RAI 03.07.02-24, Supplement 1, Revision 1**QUESTION:****Follow-up Question to RAI 03.07.02-15 (STP-NRC-100036)**

UHS Basin and RSW Pump House:

RSW Piping Tunnel:

Figure 3H.7-33: At-Rest Lateral Earth Pressure on the DGFOT Walls

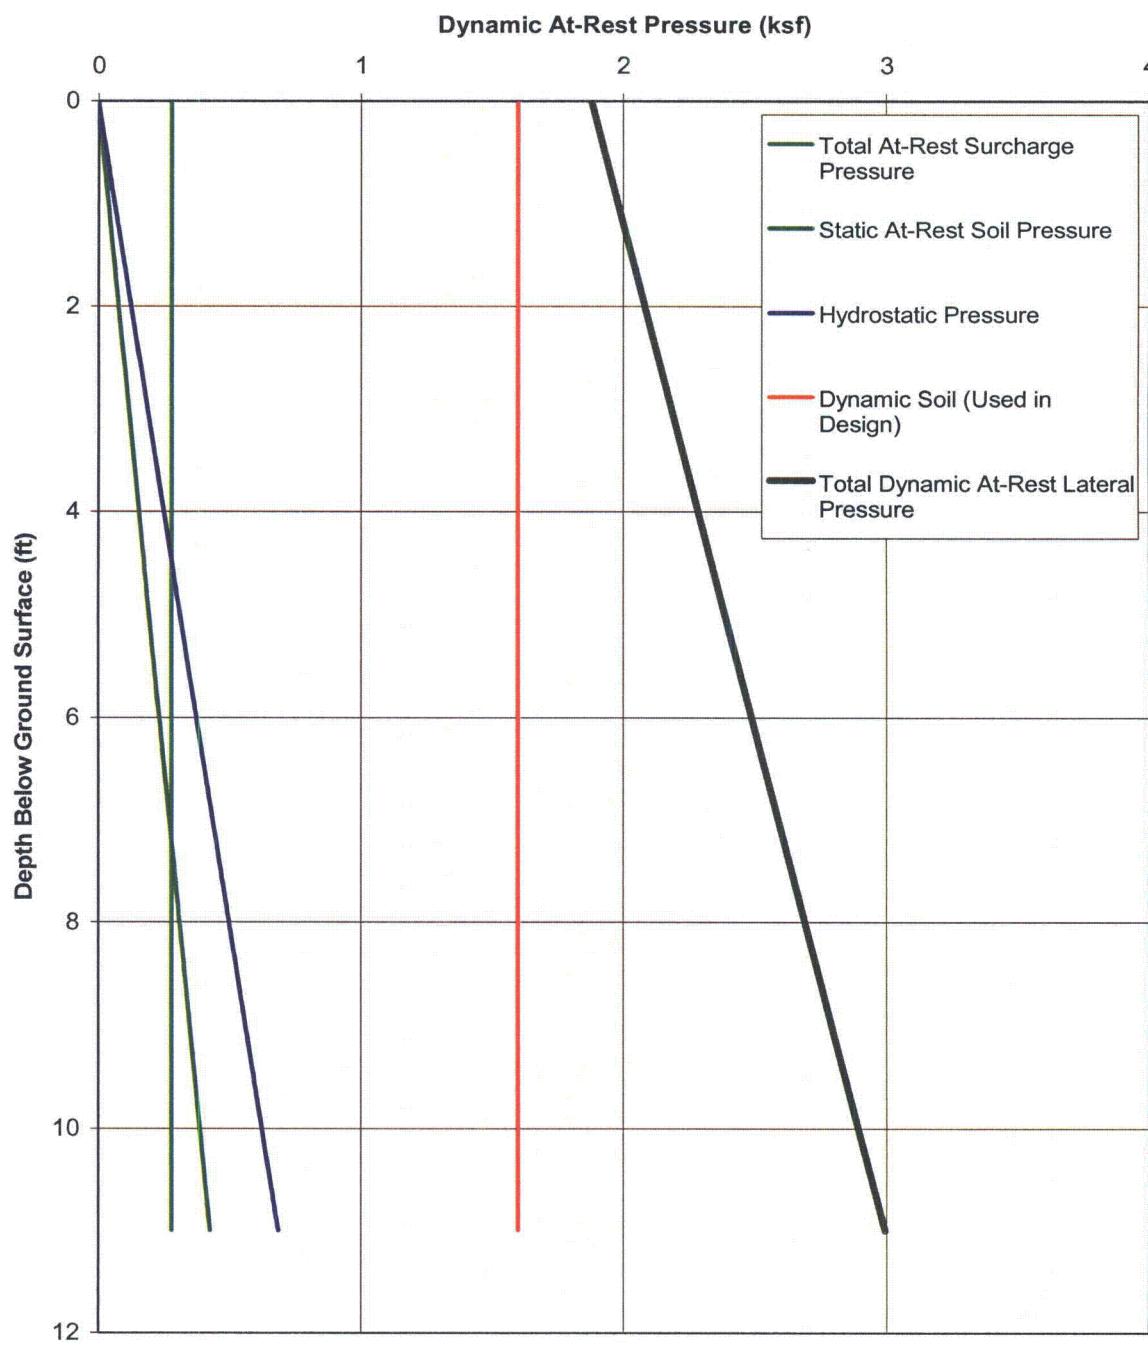
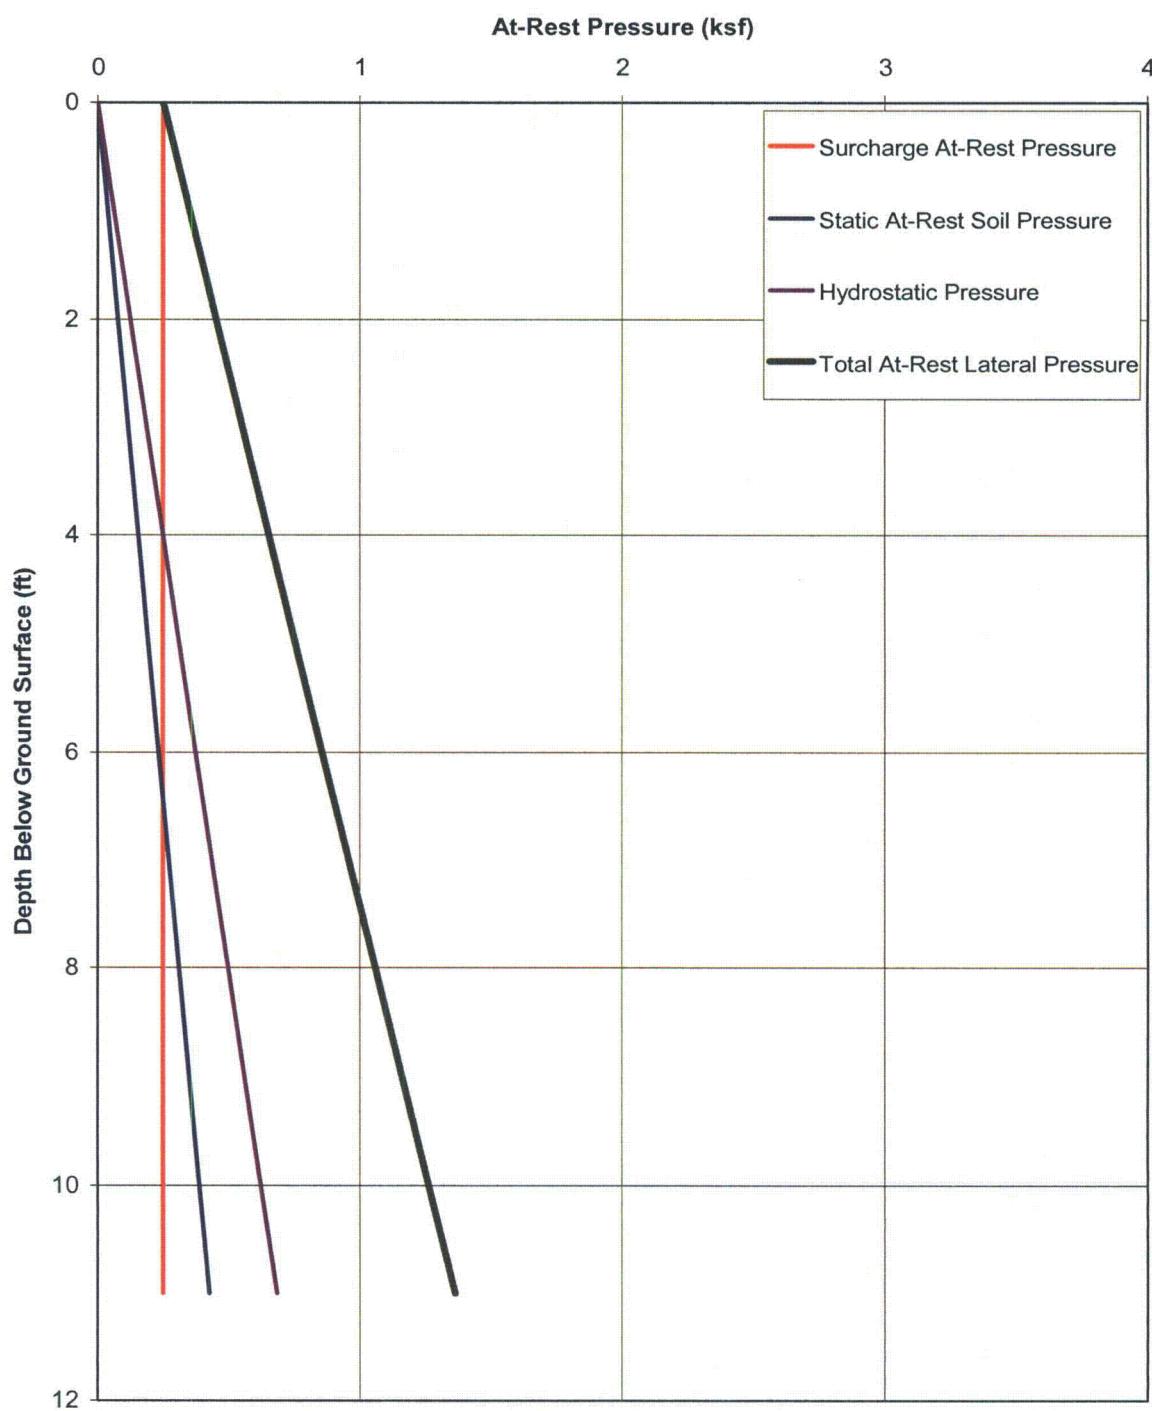
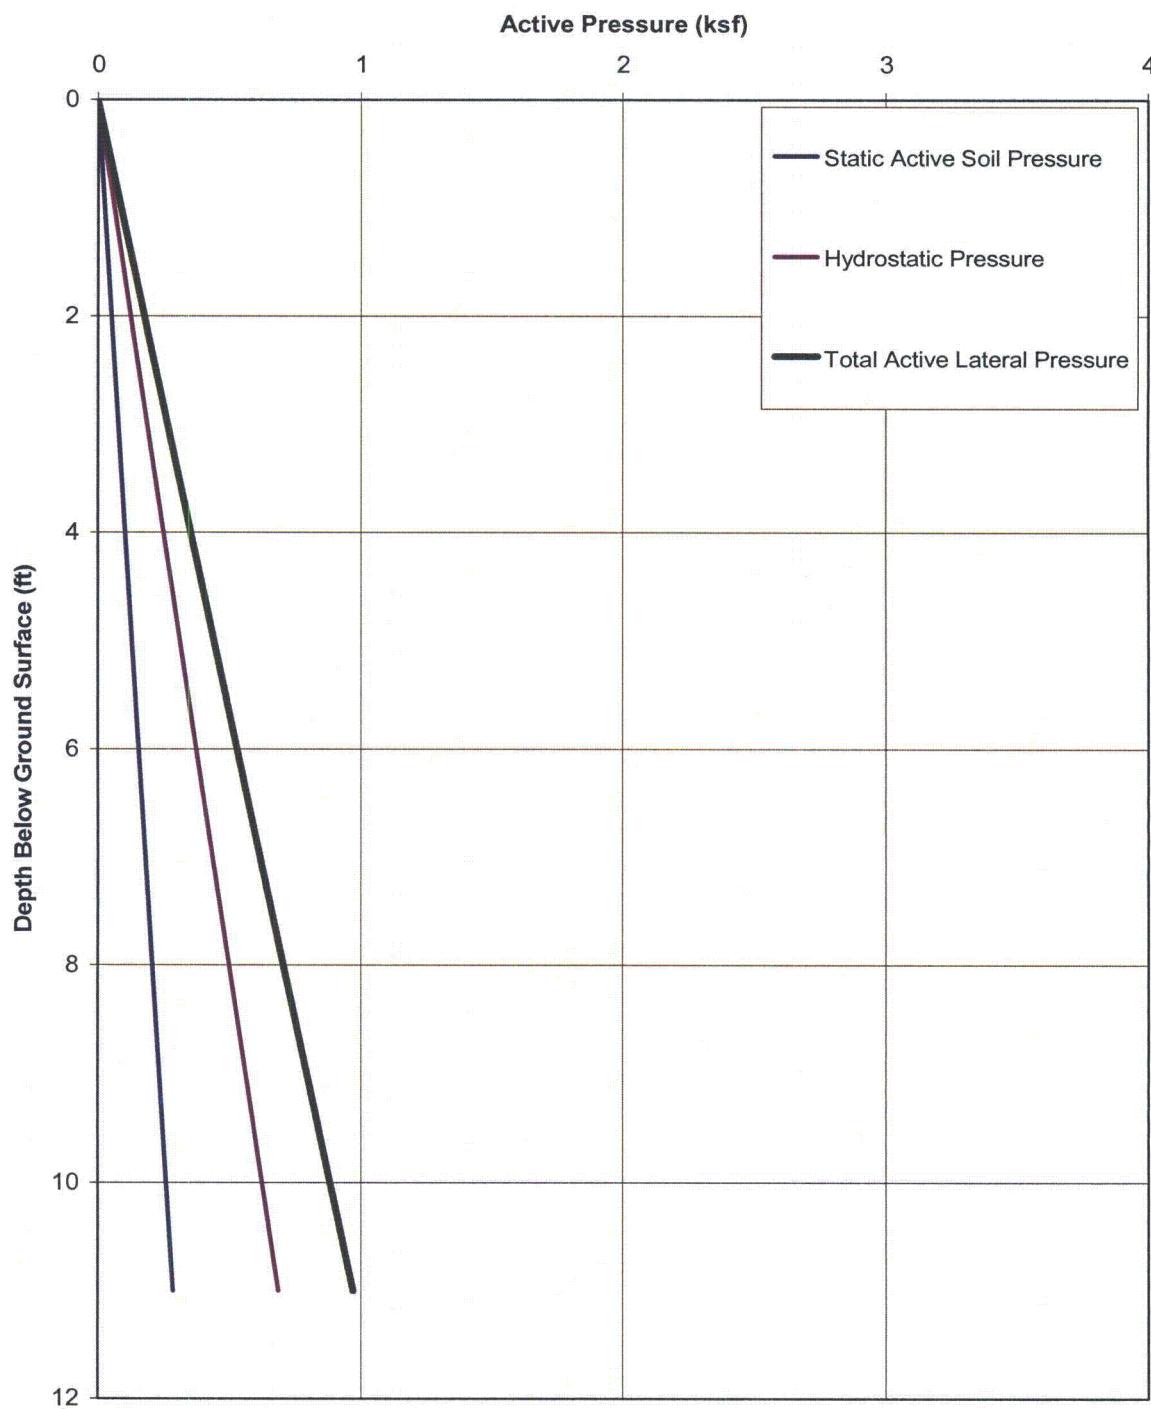
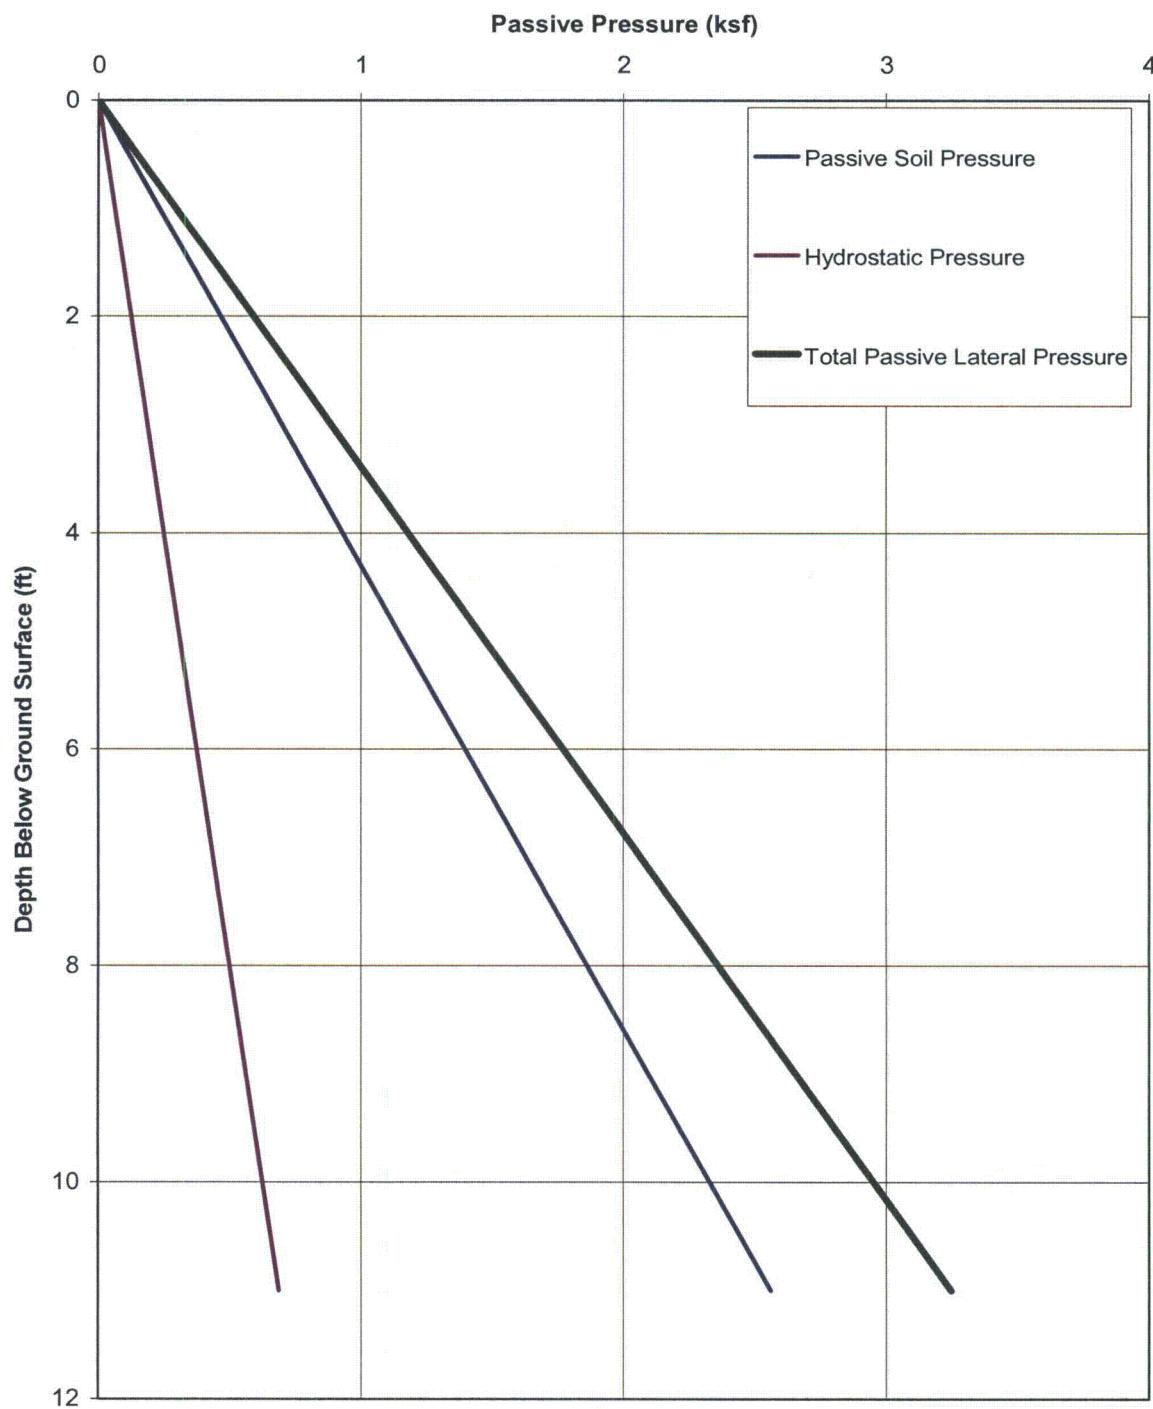
- b) For the staff to conclude that the design of structures with deep foundations, such as the Reactor Building (RB) and Control Building (CB), is satisfactory for the site, the site-specific design loads are needed to compare with the design loads used for the DCD. Lateral soil pressure is one such load. Therefore, please provide the lateral soil pressures for the RB and the CB, and compare these calculated pressures with those used in the ABWR standard plant design. Please also confirm if the effects of adjacent structures are considered in computing the lateral soil pressures, and if not, provide the justification for not doing so.

The SSSI incremental seismic soil pressure curves for the standard plant Diesel Generator Fuel Oil Tunnel (DGFOT) have been provided in COLA Part 2, Tier 2, Figures 3H.7-5 through 3H.7-8, in the response to RAI 03.08.04-30, submitted with STPNOC letter U7-C-STP-NRC-110008, dated January 17, 2011. The at-rest, dynamic at-rest, active and passive soil pressure profiles are provided in Figures 3H.7-2 and 3H.7-33 through 3H.7-35, included in Enclosure 2 of this response.
